## ADDENDUM #2

Reference: UDOT Region 3 Fire System Upgrades  
DFCM Project No. 05233900

**Subject:** Revisions to Fire Protection Drawings and Specifications for Addendum 2

FIRE ALARM  
SYSTEM PLAN  
ADMINISTRATION  
BUILDING LEVEL 2  
FP-3.2

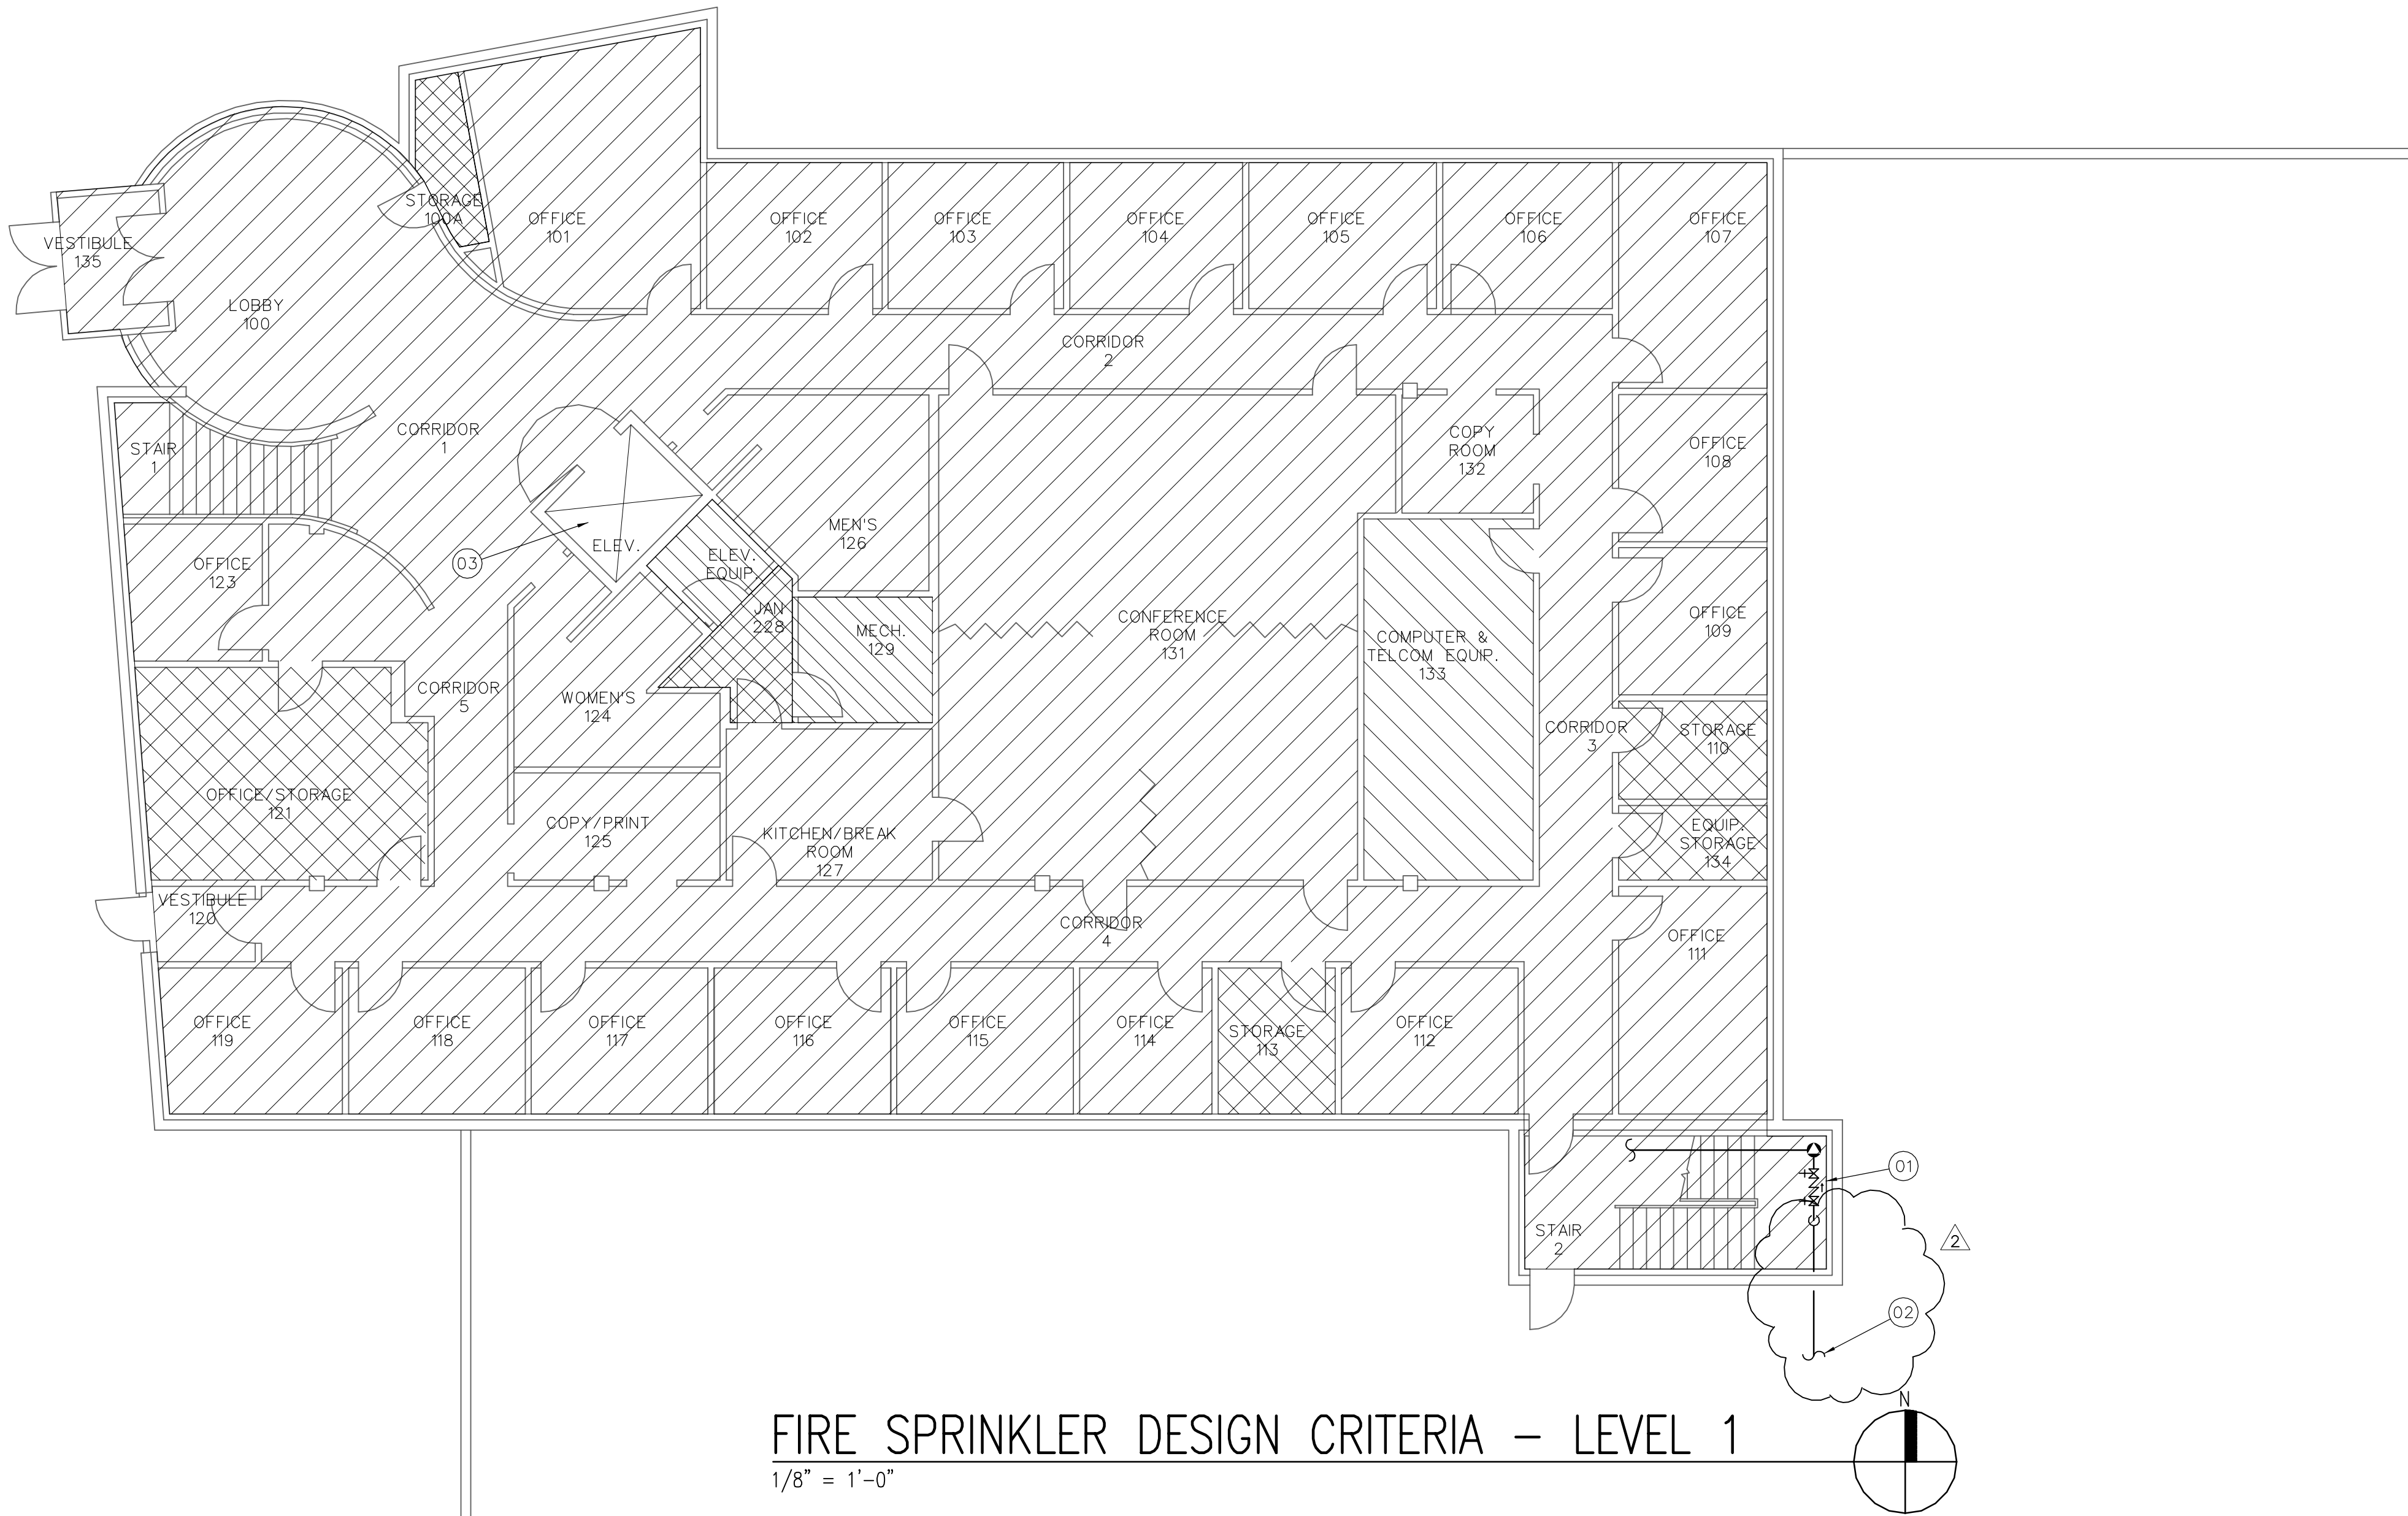
1. Indicated existing door hold-open device on door at elevator lobby and added key note 9 to specify connection of existing door hold-open device to new fire alarm system.
2. Relocated control modules, heat and smoke detectors for elevator recall from 2<sup>nd</sup> floor to elevator equipment room on 1<sup>st</sup> level.
3. Edited general note 7 to allow the use of flexible conduit and metallic clad (MC) cable.
4. Added general note 14 to require demolition/removal of existing system that provides elevator recall and actuation of fire/smoke dampers.

FIRE SPRINKLER  
DESIGN CRITERIA  
WAREHOUSE/SHOP  
BUILDING  
FP-2.5

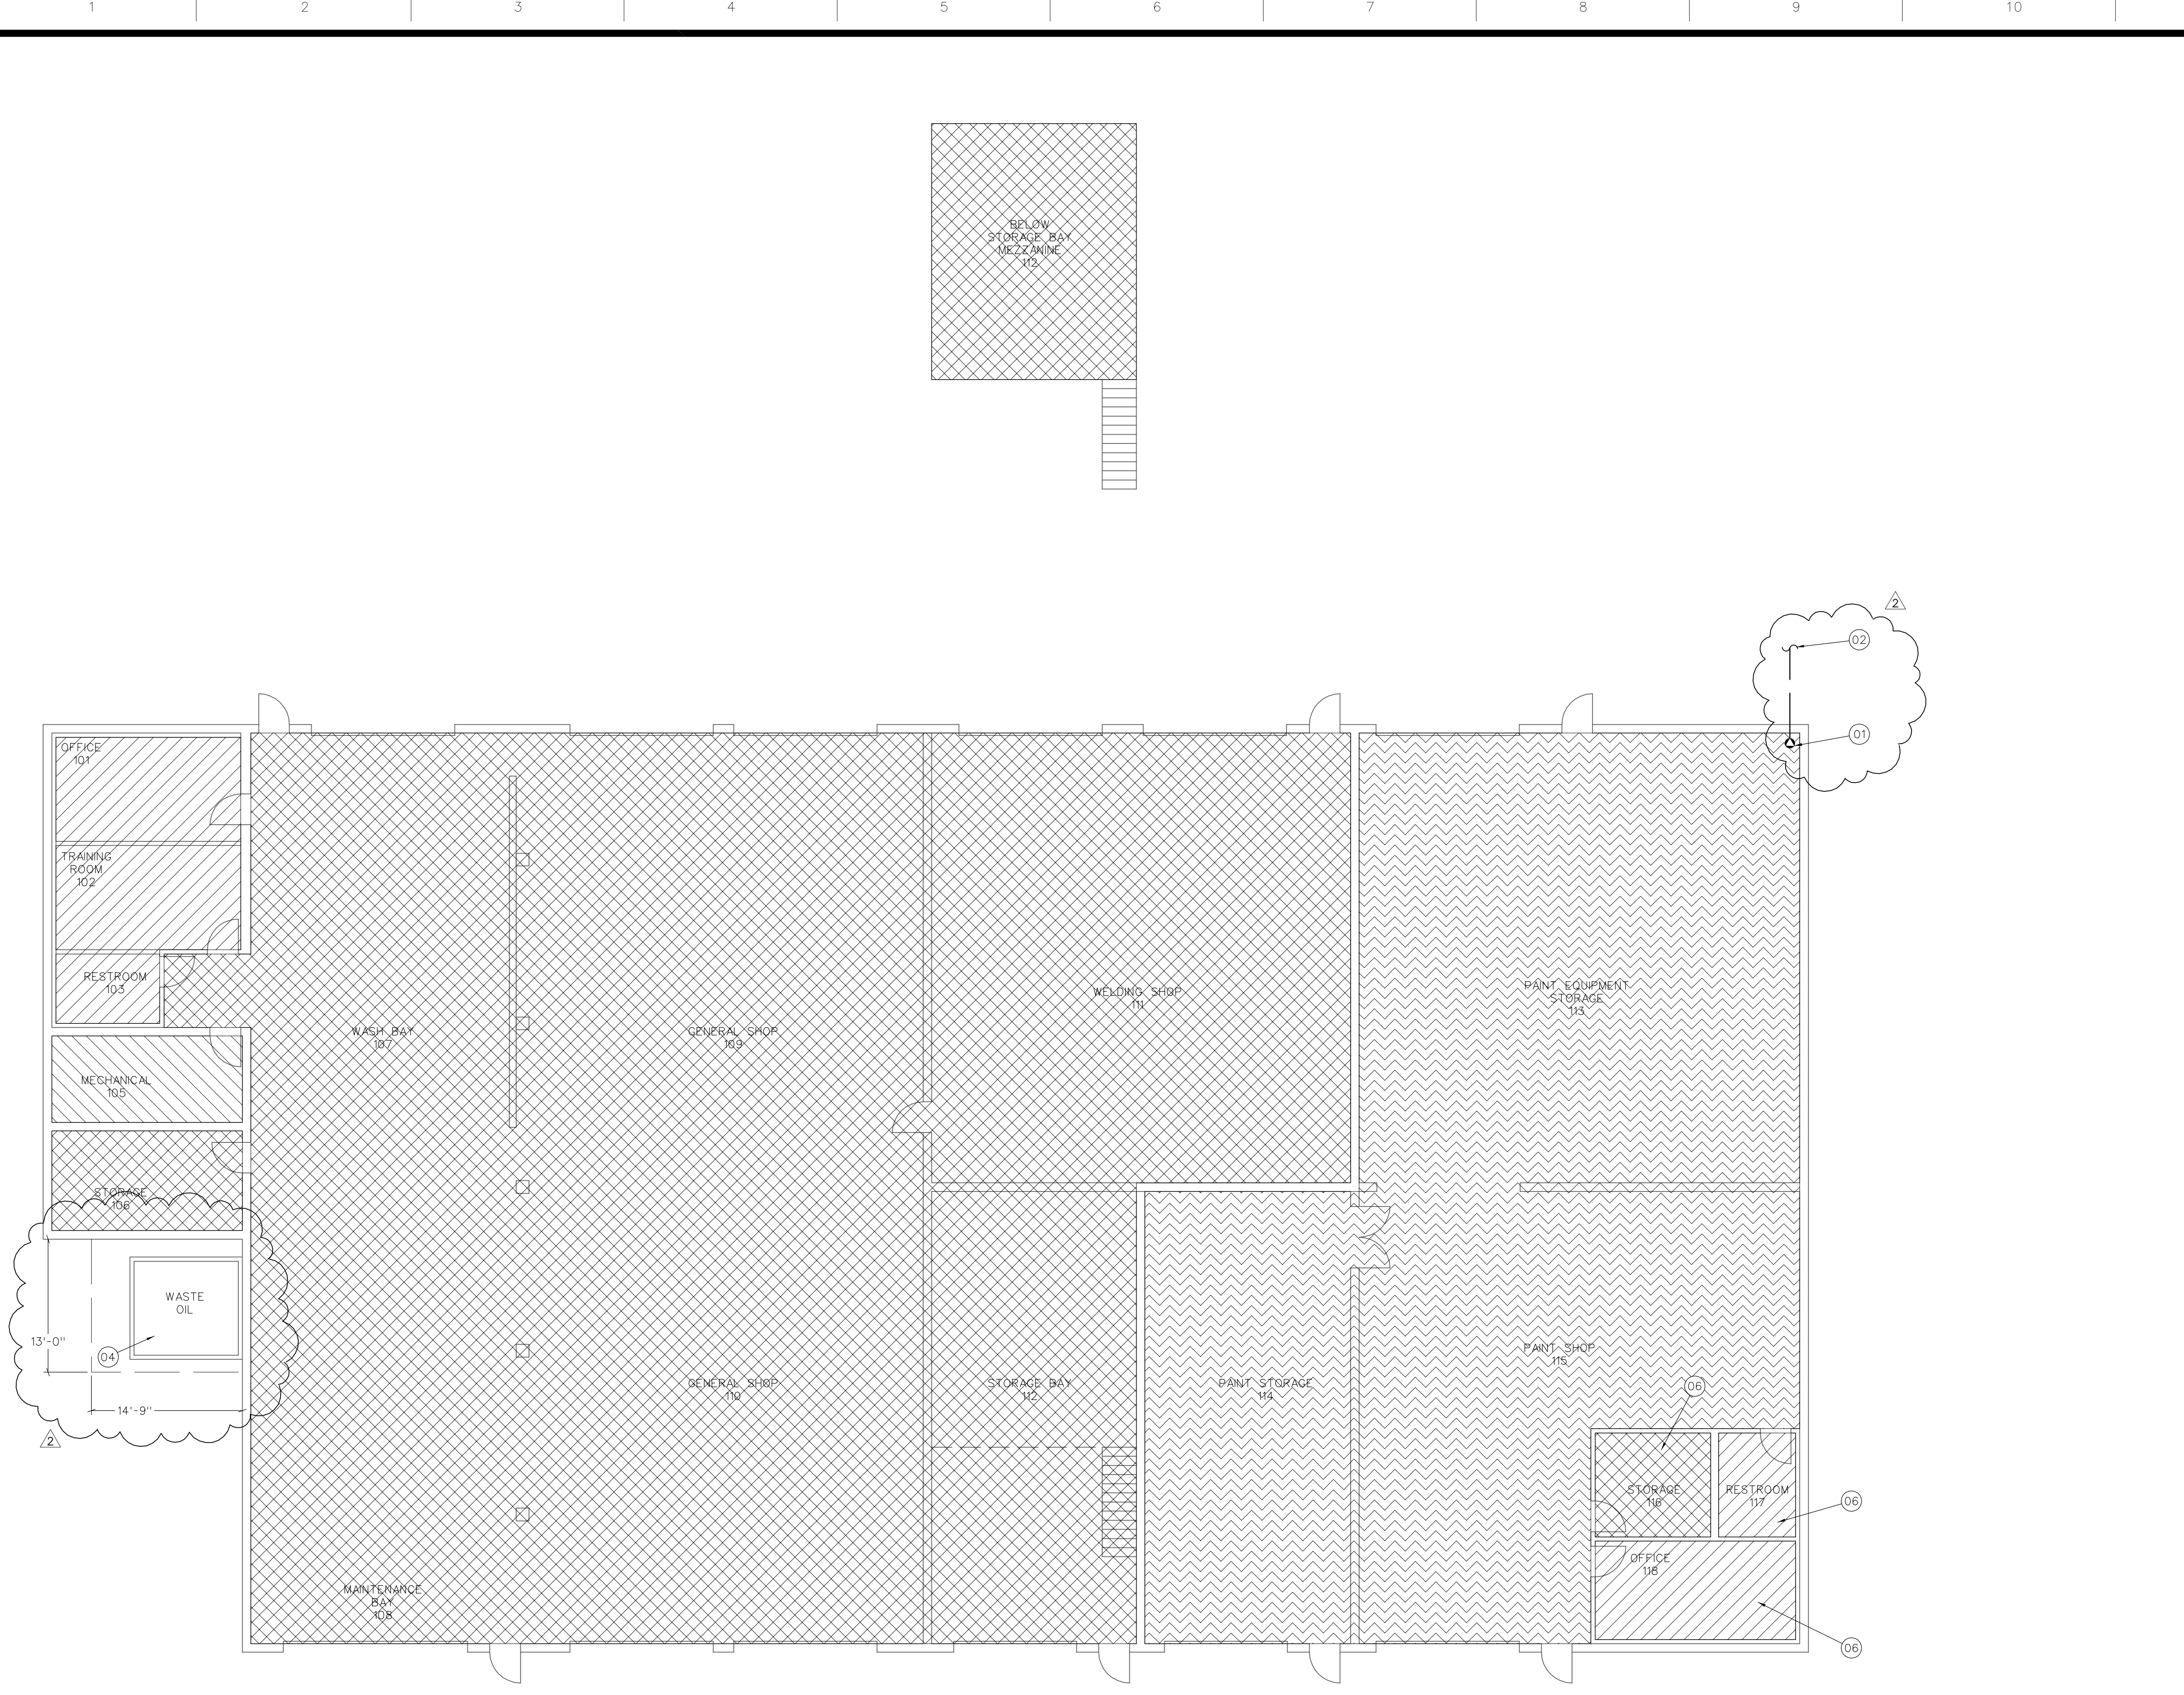
1. Edited key note 2 to indicate that contractor must coordinate with locations of existing buried utilities. Existing buried utilities to be marked by owner.
2. Revised design density legend and design density plan in portion of Electric Shop to require a discharge density of 0.495 gpm/sq ft to protect the existing high piled storage present in that area.

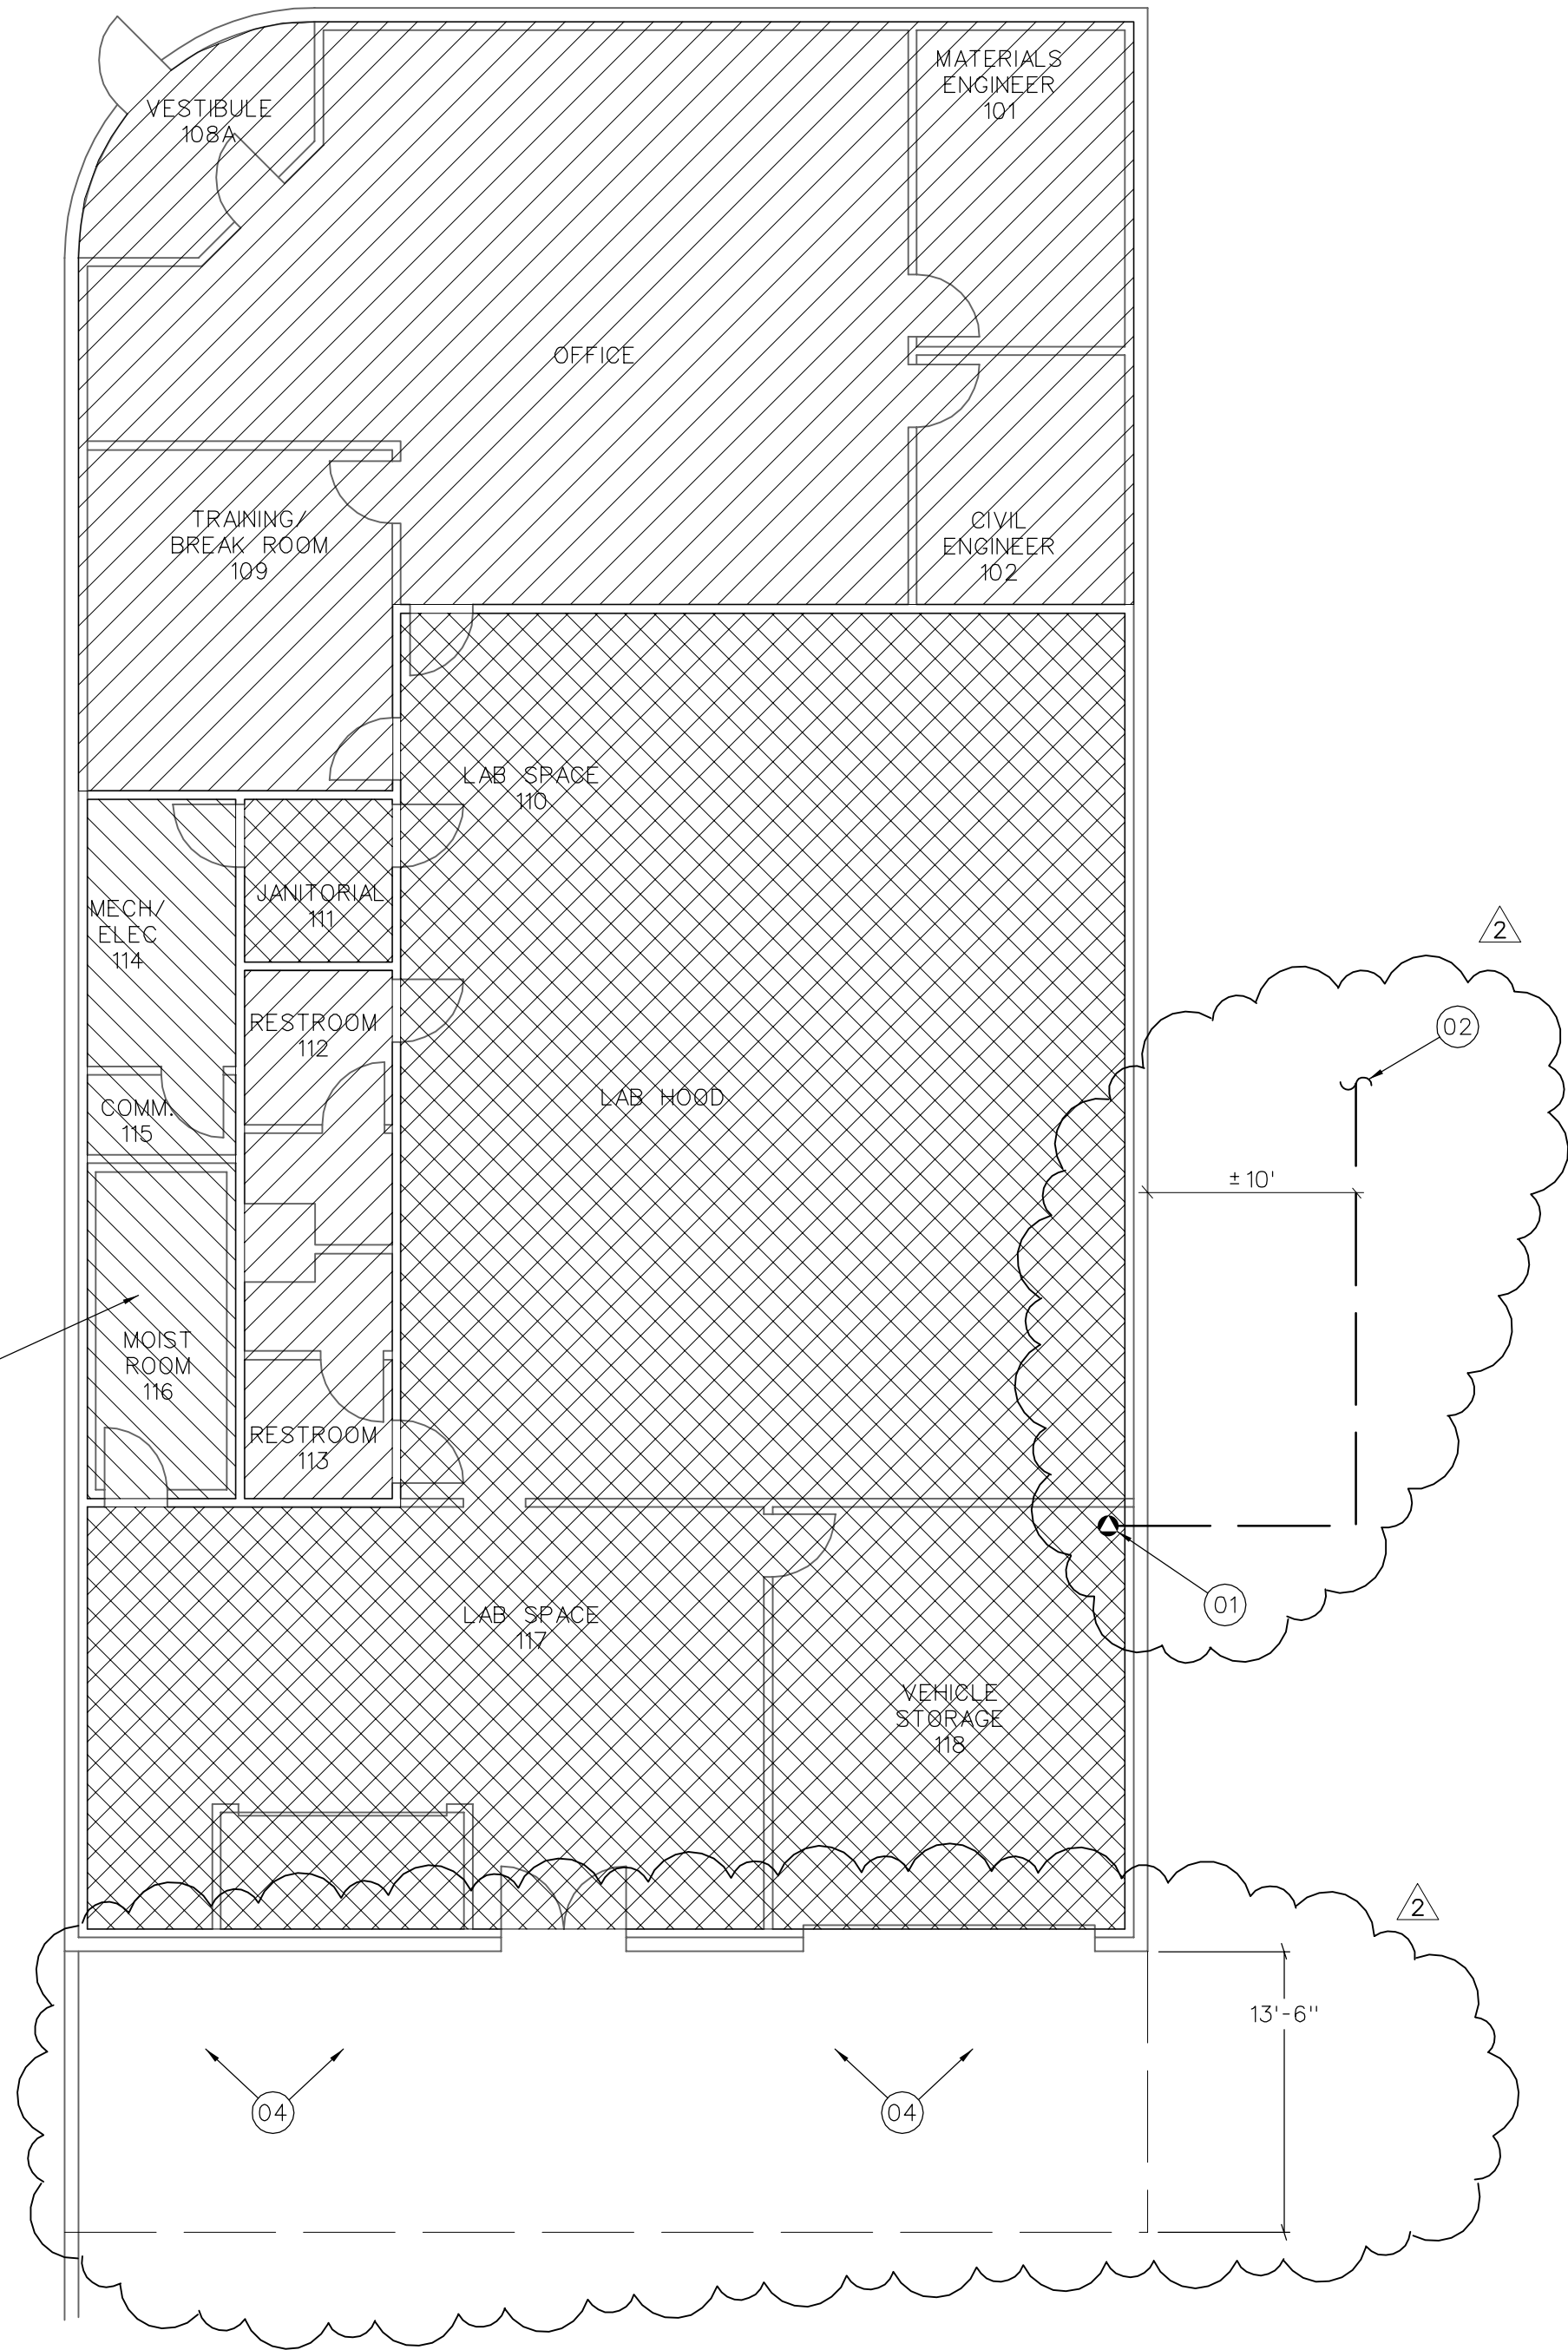
1. Edited key note 2 to indicate that contractor must coordinate with locations of existing buried utilities. Existing buried utilities to be marked by owner.
2. Edited drawing to show size of existing exterior canopy over Waste Oil.
3. Added key note 4 to indicate that fire sprinkler protection is required for exterior canopy over Waste Oil.
